NO. 23
April 11, 1947

CARBURETOR VAPOR RETURN LINE HOSE REPLACEMENT

AIRPLANES AFFECTED:

NAV-4-2 through NAV-4-850.

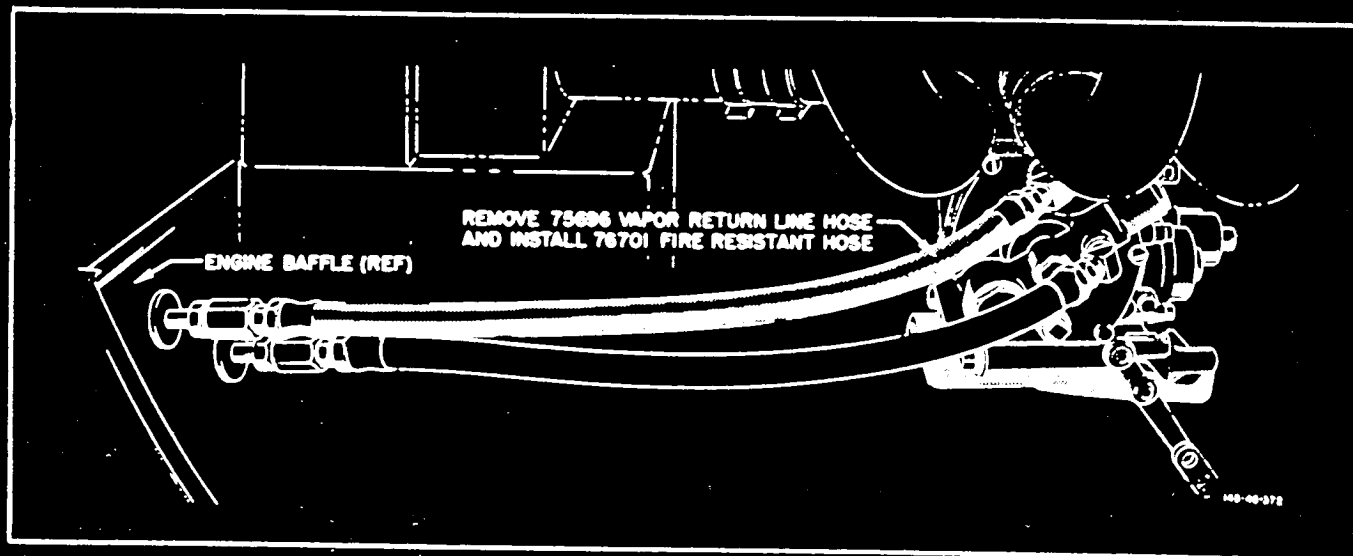
Airplanes NAV-4-851 and subsequent will have the metal vapor return line routed through the firewall in such a manner that a fire resistant hose is not required. Fire resistant hose is identified by a broken red and a broken white stripe running lengthwise of the hose.

Install 76701 fire resistant hose furnished in 145-89027 kit as shown:
